ADDENDUM NO. 1
February 26, 2021
224126

RE: **CITY OF BARRE, VERMONT**
BIOSOLIDS IMPROVEMENTS PROJECT

FROM: DuBOIS & KING, INC.
P.O. Box 339
Randolph, Vermont 05060
(802) 728-3376

WASTE GAS BURNER PLAN VIEW

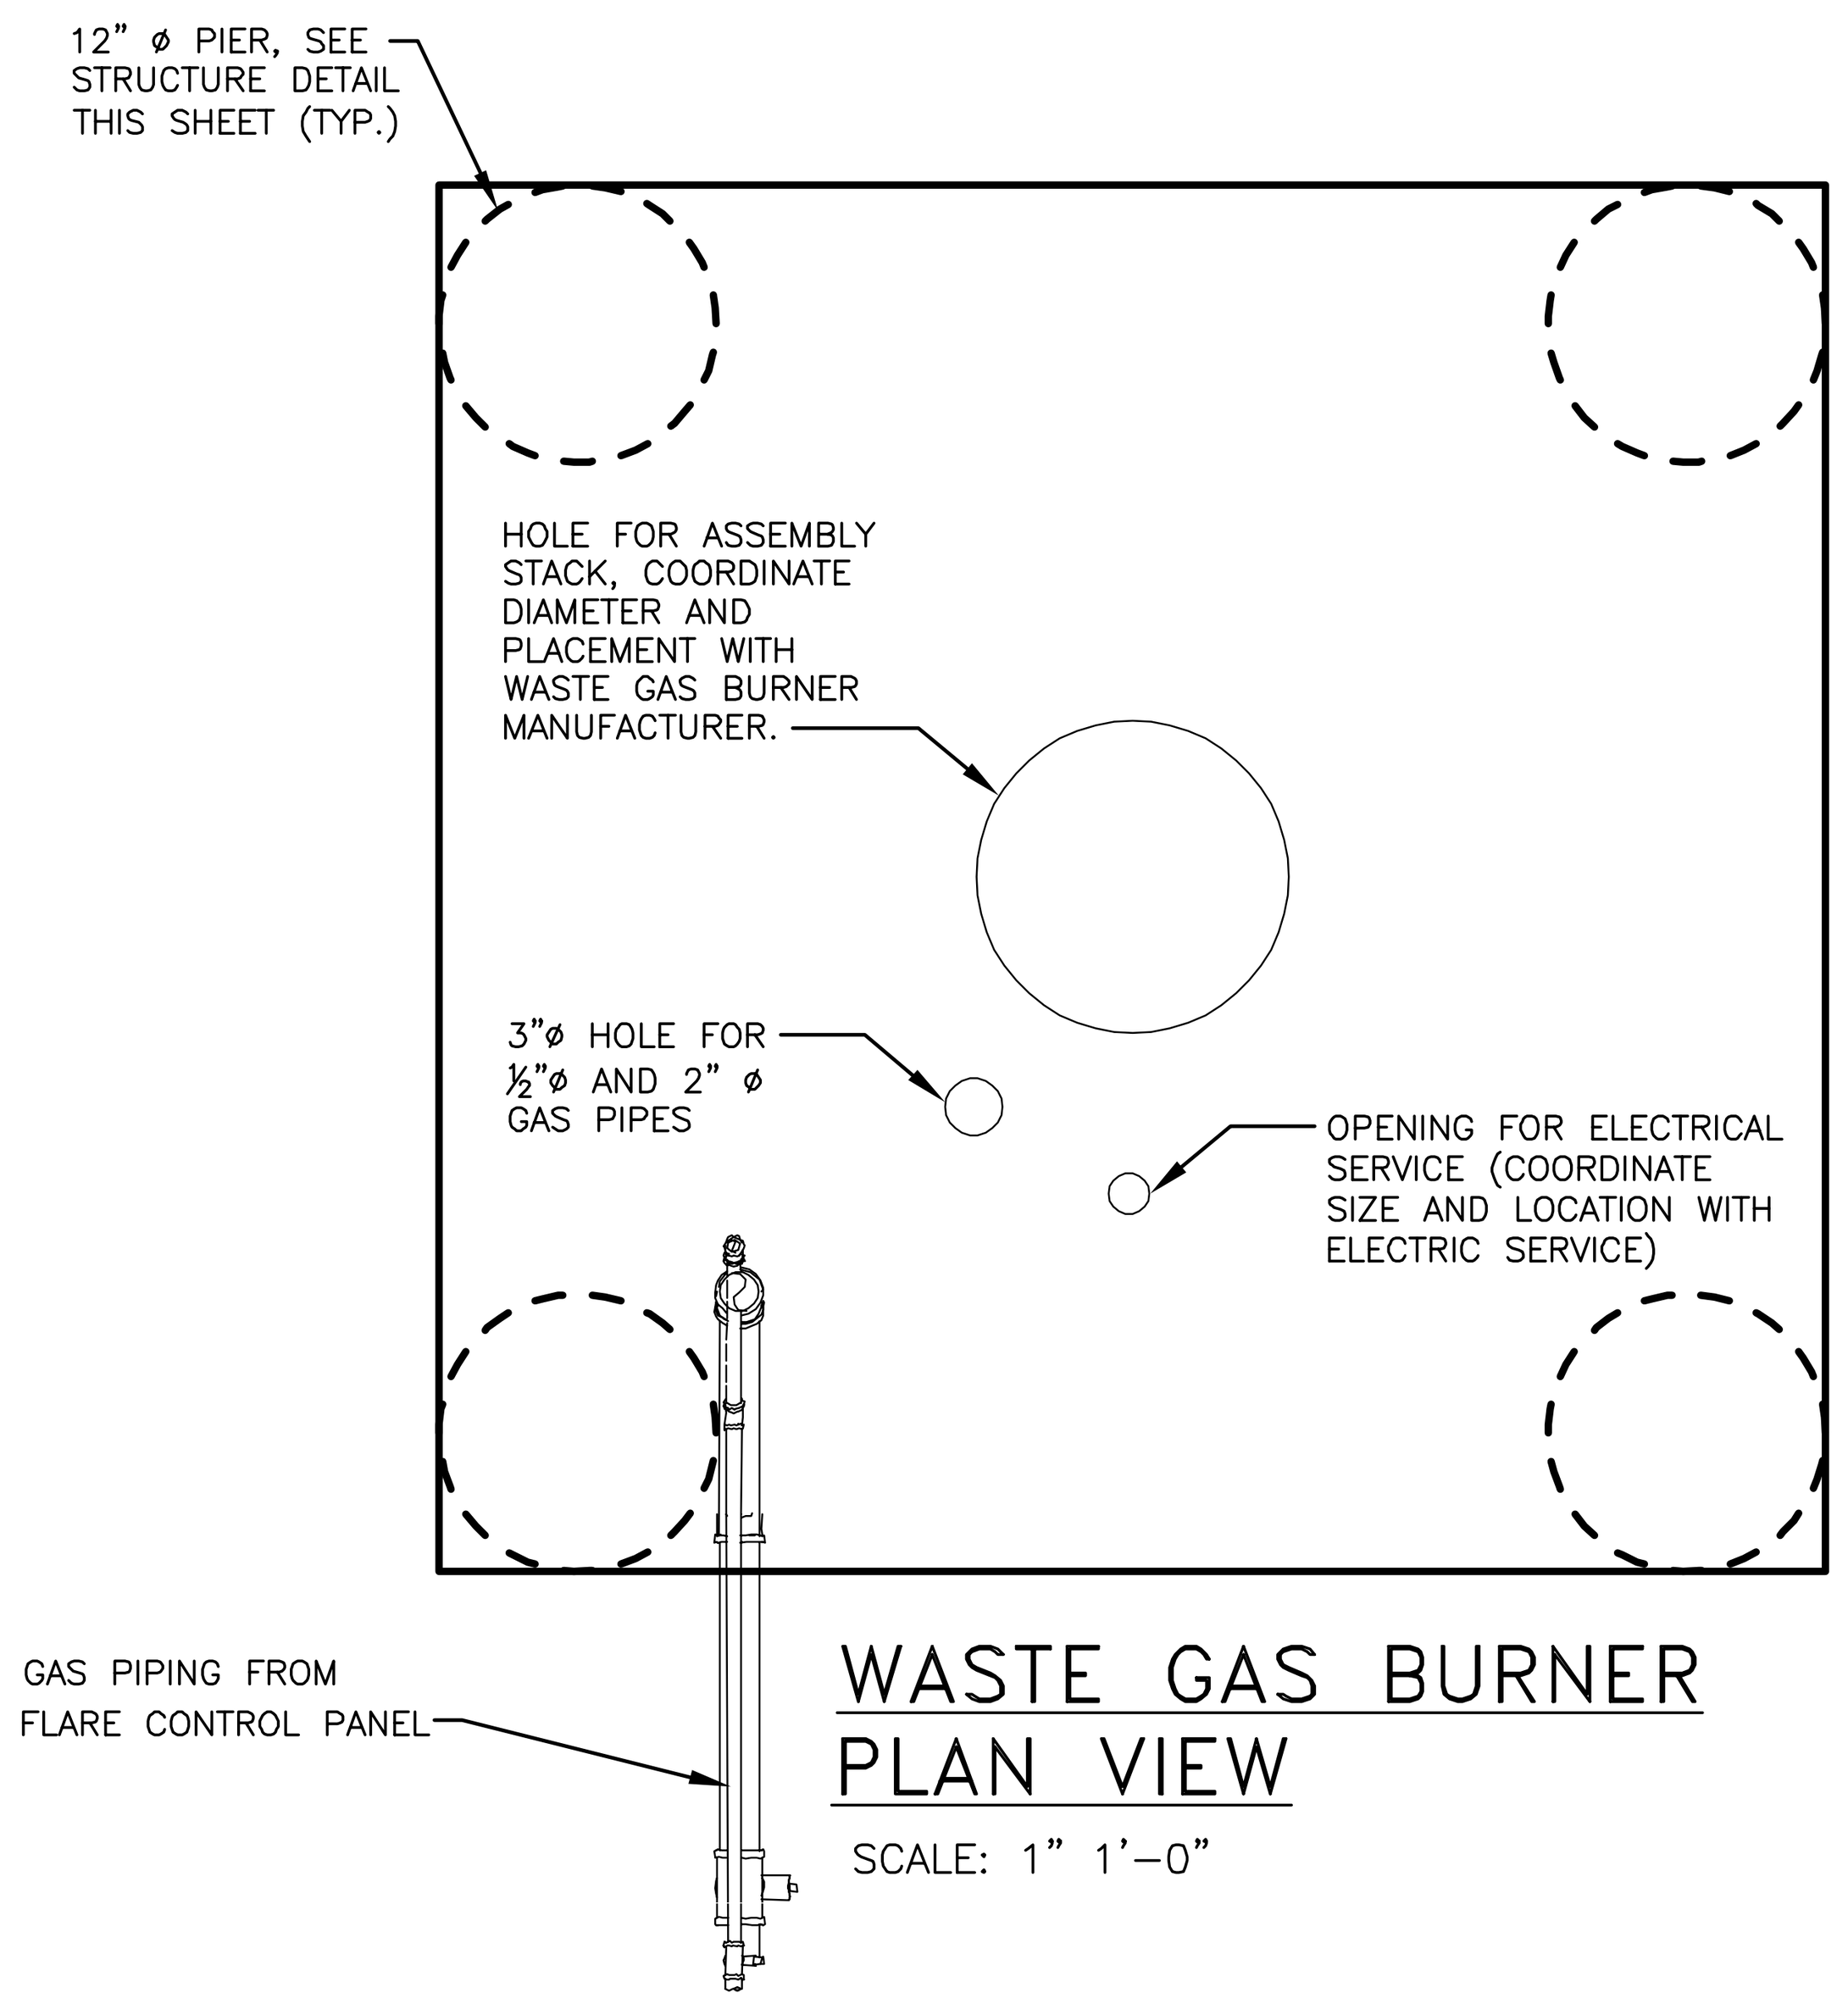
Question 12: In reference to **Sheet C8**, will support piers be required to support the 10" channel?

6. Reissue sheet C9. See **Attachment 3**.

Answer 12: The channel was sized/designed to span the identified length. The channel is attached to the concrete pier on one end. The reissued Sheets C8 and C9 identify a support on the concrete pad associated with the Gas Burner Control Panel.
